6th Edition (2017) Update to the Florida Building Code Proposed Code Modifications

Proposed Code Modifications

Including Comments

Sub Code: Energy Conservation

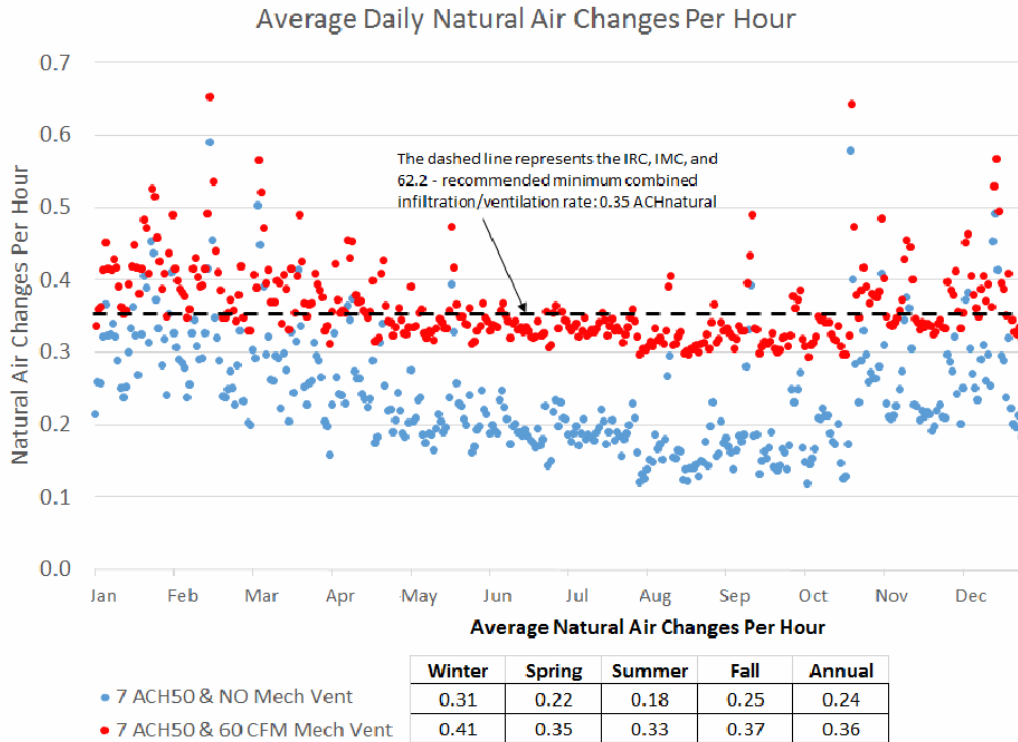
To insure that occupants are able to receive the minimum combined infiltration and ventilation rate promulgated by model codes and standards (i.e., 0.35 natural air changes per hour), the air leakage target should not be increased without simultaneously requiring mechanical ventilation. This comment proposes to continue to require mechanical ventilation if Florida elects to increase the air tightness target to 7 ACH50.

Following is a chart created using DOE's EnergyPlus software that shows the average daily combined infiltration and ventilation rate for a typical 2,600 ft² three-bedroom, single-family home located in Orlando. The chart examines daily, seasonal, and annual average combined infiltration and ventilation rates for the same typical home across two scenarios:

- Scenario A: 7 ACH50 tightness; no mechanical ventilation (as proposed by EN6573)
- Scenario B: 7 ACH50 tightness; mechanical ventilation in accordance with IRC M1507 (EN6573 amended to include mechanical ventilation)

Under Scenario A (7 ACH 50 with no mechanical ventilation), the average annual air change rate is 0.24 natural air changes per hour, frequently dipping below 0.15 in the summer months. Research has shown that formaldehyde emissions from building materials increase with increasing temperature and relative humidity, and formaldehyde concentrations increase with decreasing infiltration/ventilation rates. In other words, formaldehyde emissions and concentrations are likely to spike in the summer under Scenario A when natural infiltration is at its lowest. Resultant poor indoor air quality can significantly diminish occupants' health. In fact, research suggests that poor IAQ is responsible for around \$500 annually in health related costs per person in the U.S., which translates to \$10 billion annually in Florida.*

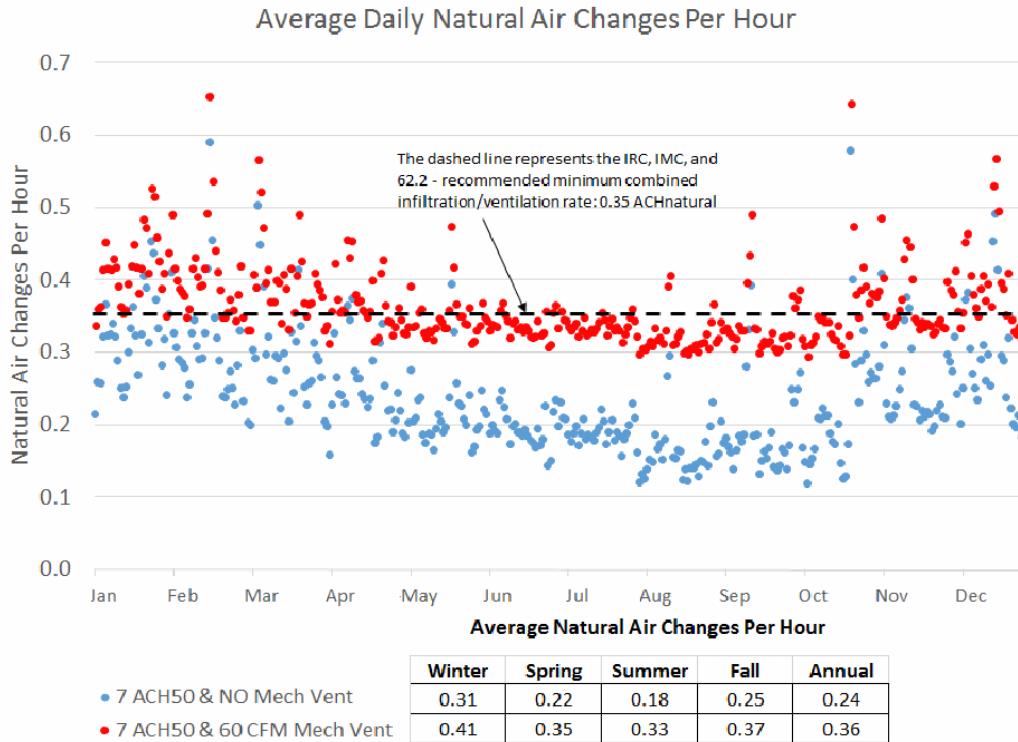
To insure that occupants are able to receive the *minimum* combined infiltration and ventilation rate promulgated by model codes and standards (i.e., 0.35 natural air changes per hour), the air leakage target should not be increased without simultaneously requiring mechanical ventilation. This comment proposes to continue to require mechanical ventilation if Florida elects to increase the air tightness target to 7 ACH50.

Following is a chart created using DOE's EnergyPlus software that shows the average daily combined infiltration and ventilation rate for a typical 2,600 ft² three-bedroom, single-family home located in Orlando. The chart examines daily, seasonal, and annual average combined infiltration and ventilation rates for the same typical home across two scenarios:

- Scenario A: 7 ACH50 tightness; no mechanical ventilation (as proposed by M 6820)
- Scenario B: 7 ACH50 tightness; mechanical ventilation in accordance with IRC M1507 (M 6820 amended to include mechanical ventilation)

Under Scenario A (7 ACH 50 with no mechanical ventilation), the average annual air change rate is 0.24 natural air changes per hour, frequently dipping below 0.15 in the summer months. Research has shown that formaldehyde emissions from building materials increase with increasing temperature and relative humidity, and formaldehyde concentrations increase with decreasing infiltration/ventilation rates. In other words, formaldehyde emissions and concentrations are likely to spike in the summer under Scenario A when natural infiltration is at its lowest. Resultant poor indoor air quality can significantly diminish occupants' health. In fact, research suggests that poor IAQ is responsible for around \$500 annually in health related costs per person in the U.S., which translates to \$10 billion annually in Florida.*

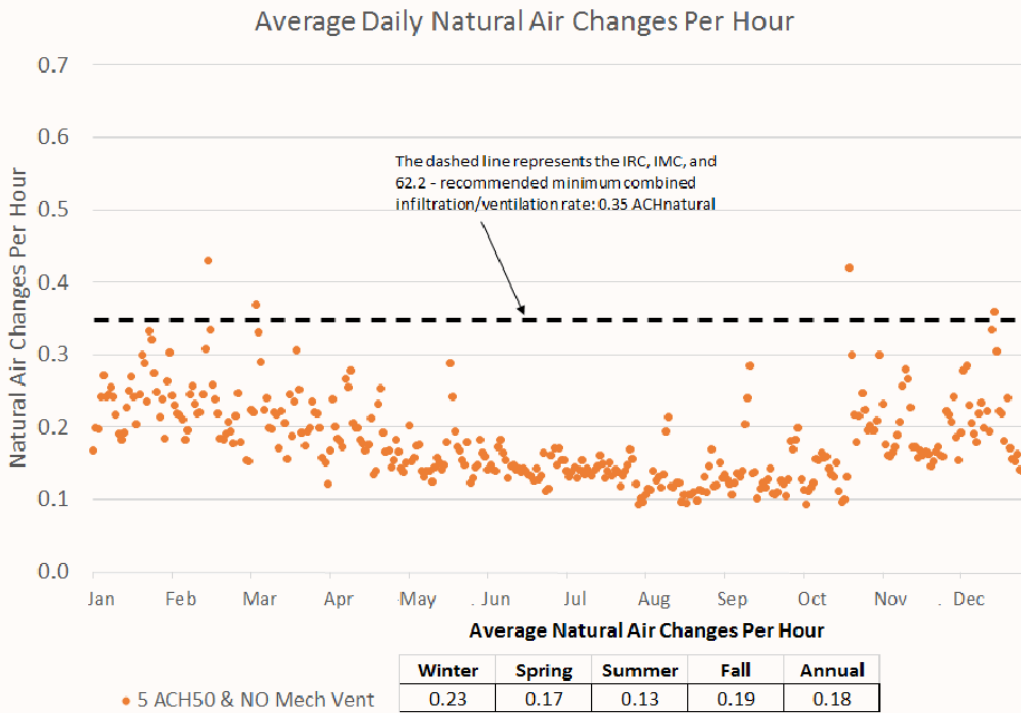
Recommend disapproval of this proposal. The proposal’s rationale states that its intent is to clarify “that mechanical ventilation is not necessary.” The proponent provides no technical basis to support this claim, which runs counter to engineering calculations and research showing that natural ventilation and infiltration are insufficient to achieve acceptable indoor air quality.

As an example, following is a chart created using DOE’s EnergyPlus software that shows the average daily combined infiltration and ventilation rate for a typical 2,600 ft² three-bedroom, single-family home located in Orlando with a building air tightness of 5 ACH50 and *no* mechanical ventilation. The average annual natural air change rate for this typical home is 0.18 (just over half of the 0.35 air changes per hour promulgated by model codes and standards), with a seasonal low of 0.13 in the summer. Research has shown that formaldehyde emissions from building materials increase with increasing temperature and relative humidity, and formaldehyde concentrations increase with decreasing infiltration/ventilation rates. In other words, formaldehyde emissions and concentration are likely to spike in the summer when natural infiltration is at its lowest. Resultant poor indoor air quality can significantly diminish occupants’ health. In fact, research suggests that poor IAQ is responsible for around \$500 annually in health related costs per person in the U.S., which translates to \$10 billion annually in Florida.*

M 6819: Rationale to Disapprove
Submitted by: Mike Moore, P.E., Newport

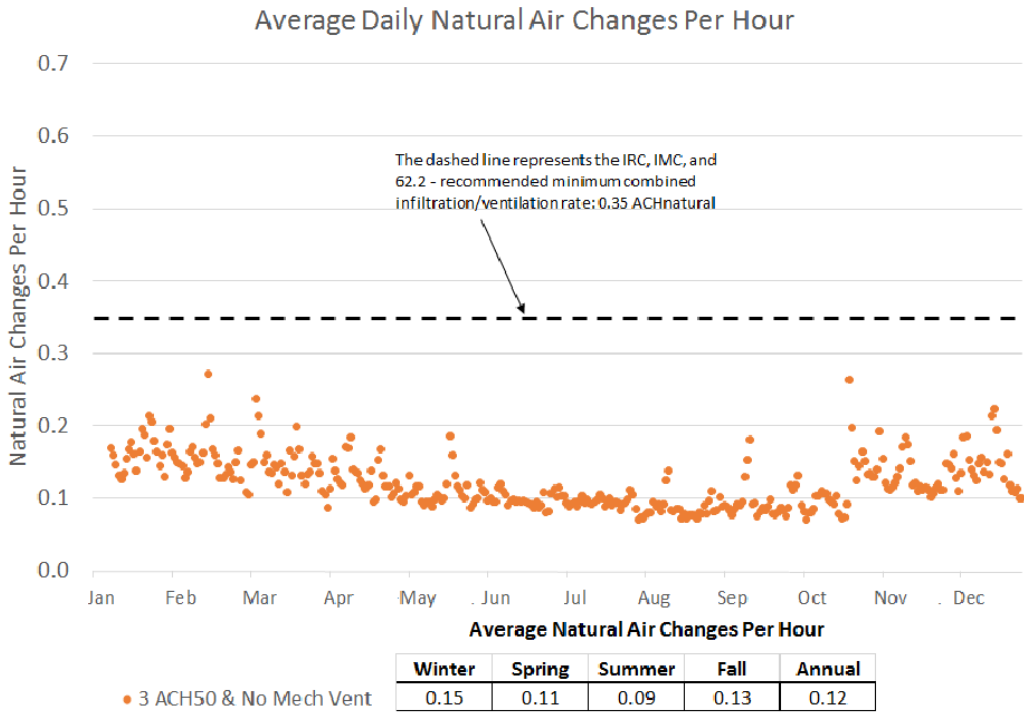
Recommend disapproval of this proposal. The proponent makes the unsubstantiated claim that the proposal “will improve the health, safety, and welfare of the general public by instituting a reasonable level for requiring whole house mechanical ventilation systems”. There is no technical basis to support this claim, which runs counter to engineering calculations and research showing that natural ventilation and infiltration are insufficient to achieve acceptable indoor air quality.

As an example, following is a chart created using DOE’s EnergyPlus software that shows the average daily combined infiltration and ventilation rate for a typical 2,600 ft² three-bedroom, single-family home located in Orlando with a building air tightness of 3 ACH50 and *no* mechanical ventilation, as proposed by the proponent. The average annual natural air change rate for this typical home is 0.12 (roughly a third of the 0.35 air changes per hour promulgated by model codes and standards), with a seasonal low of 0.09 in the summer. Research has shown that formaldehyde emissions from building materials increase with increasing temperature and relative humidity, and formaldehyde concentrations increase with decreasing infiltration/ventilation rates. In other words, formaldehyde emissions and concentration are likely to spike in the summer when natural infiltration is at its lowest. Resultant poor indoor air quality can significantly diminish occupants’ health. In fact, research suggests that poor IAQ is responsible for around \$500 annually in health related costs per person in the U.S., which translates to \$10 billion annually in Florida.*
